SERVICETEKNOTES

TABLE OF CONTENTS

DC5010 H.F. COUNTING FLUCTUATES BY 4 OR 5 LEAST SIGNIFICANT DIGITS

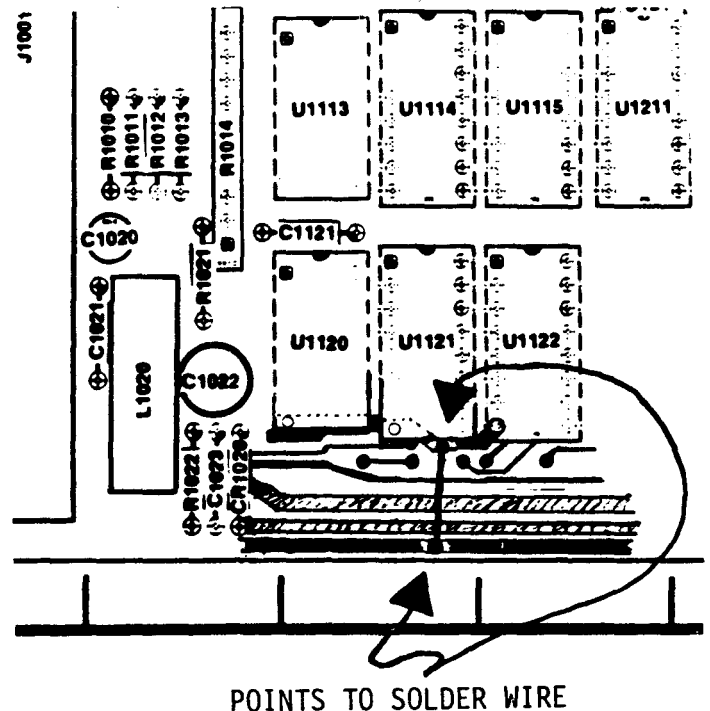
Fluctuation of >10kHz on the last four to five L.S.D.'s may occur when measuring frequencies between 100MHz to 350MHz (the symptom normally shows at 350MHz). First, verify the signal source to ensure it is not the cause of the erratic display. If the source is stable,

then the following modification should be done to improve the display:

1) One end of an insulated wire is soldered to the ground plane run located on the bottom front of the A16 Digital Board. See the diagram for the exact location.

(Scrape the solder mask from the run at the point of soldering, being careful not to damage the run. Too much heat on the run can separate it from the board, so use care when soldering.)

2) Solder the other end of the wire to the ground plane which attaches together Pin 7 of U1120 and Pin 8 of U1121 and U1122. (Follow the soldering procedure in Step 1.)

In some extreme cases U1120 may be part of the noise and will have to be replaced.

070-1976-00 FIG. 7-4 (B)
 OLD ADJUSTMENT RANGE LIMITS -2V ($\pm .5V$)

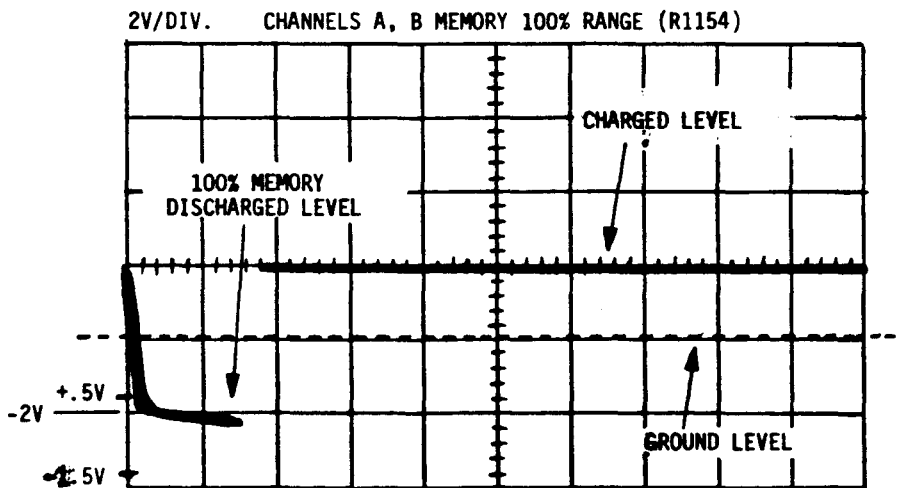
The 100% memory range test and adjustment section of the 070-1976-00 manual includes a check procedure for the 100% memory discharge voltage level. Section 9 on pages 7-6 and 7-7 checks and adjusts R1154 for a -2 volt level (with a ± 0.5 volts tolerance) below ground reference.

The tolerance range for the -2 volt (R1154) adjustment has been changed from ± 0.5 volts to to + 0.5V through -1.5V from the -2 Volt level. From Ground reference, the R1154 Adjustment range is -1.5 Volts to -3.5 Volts.

In some instances when Q1155 (151-1002-00) is a Motorola part, the wider tolerance range is necessary. The increased tolerance window will not affect memory operation or operating specifications.

070-1976-00 FIG. 7-4 (B)
 NEW ADJUSTMENT RANGE LIMITS -2V (+.5V, AND -1.5V)

485 1 MEGOHM ABERRATION ADJUSTMENT PROBLEM

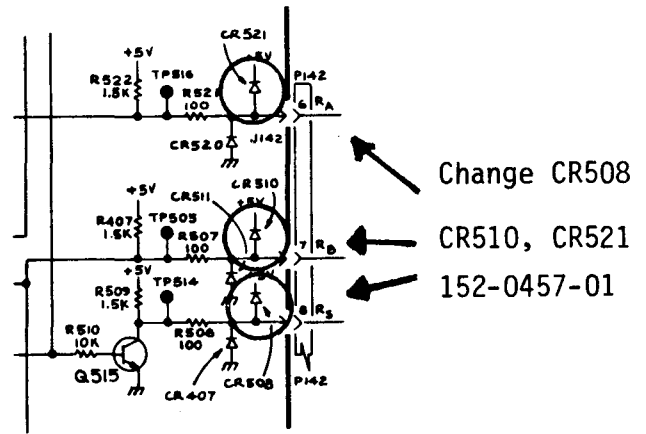
If the 1 Megohm aberrations will not adjust properly even with the 50 ohm aberrations normal, R54 on the Hi-Z board may be at fault.

1. Check R54 to ensure it is 91 ohms (within 5%). Replace if necessary.
2. If the resistance is within tolerance, very carefully heat the solder connection at each end of the resistor (use a low wattage iron). This will eliminate a high resistance connection.
3. Repeat the 1 Megohm adjustments. This procedure will solve many previously unexplained compensation problems.

690SR/6942 HI RATE OPERATION

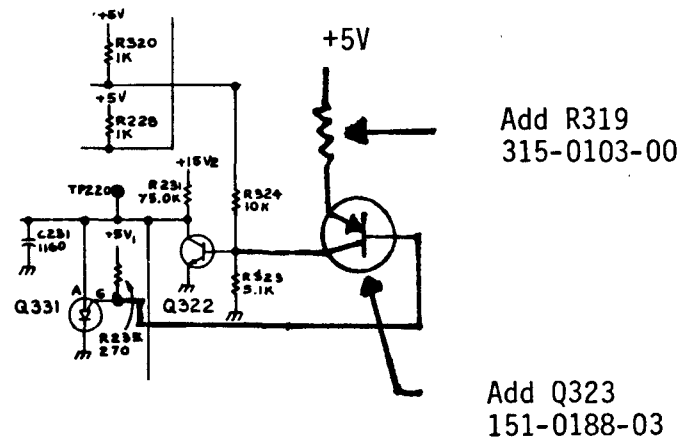
Starting at S/N B011080 on the 6942 and B010410 on the 690SR, a mod was implemented to take care of three problems in the instrument. These changes all occur on the H Delay board, A11 A2.

1. At high scan rates (37.5 kHz) the unit would not always function properly since U332 was in voltage limit prior to the retrace command occurring. To correct this, VR335, an 11 volt Zener diode was added in parallel with C335, cathode to the U332-pin 6 end of C335 (see diagram).
2. To improve reliability, CR508, CR510 and CR521 were changed to burned-in parts (see diagram).
3. With the monitor set for a high scan rate mode, it occasionally would not free-run with the interface module removed. This was caused by the valley current of Q331, a Programmable-Unjunction Transistor, being too low in some devices. To eliminate the need to select Q331 for proper operation, a kit (050-1675-00) has been established that will add another transistor and a resistor in a "teepee" fashion to the circuit. This will insure high-rate, free-run capabilities. (See diagram.)

Change CR508
 CR510, CR521
 152-0457-01

Add R319
 315-0103-00
 Add Q323
 151-0188-03

Add VR335
 152-0055-00

2215 ALTERNATE SWEEP BOARD SHIELD REMOVED

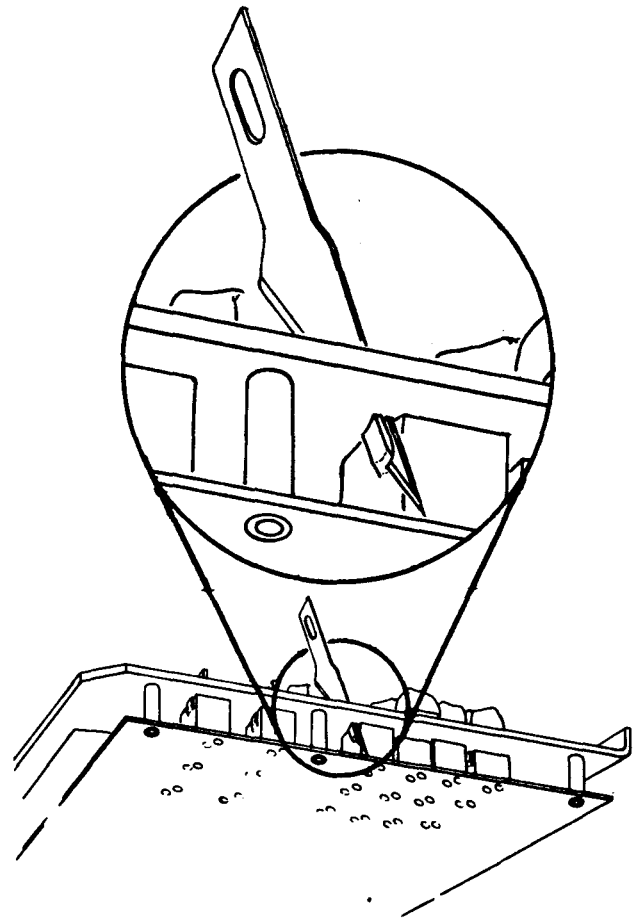
RE: FIG 2 - 15
S/N B027295

The A13 Alternate Sweep board shield has been removed from all 2215 scopes above the listed serial number. It has been determined that it was not needed for either electrical or mechanical reasons.

Use of the shield in units below this serial number is optional.

4006/4010/402X/405X CHERRY KEYSWITCH
REPLACEMENT

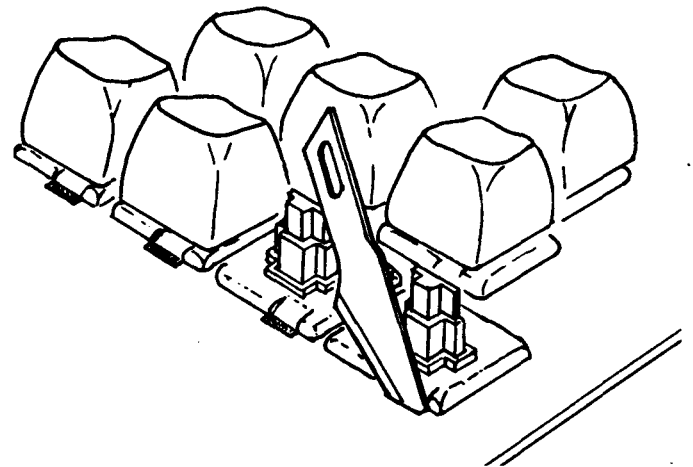
The late style cherry keyswitch, with the expanding mounting tabs, is difficult to remove from the keyboard without first cutting the mounting tabs off.

Older keyswitches have bumps, rather than locking expanding tabs; therefore, do not require cutting.

It has been found that the X-acto blade #11, 002-1040-00, with the long straight edge, works quite well in cutting the cherry keyswitch tabs. Insert blade in keyboard as pictured and cut off tab.
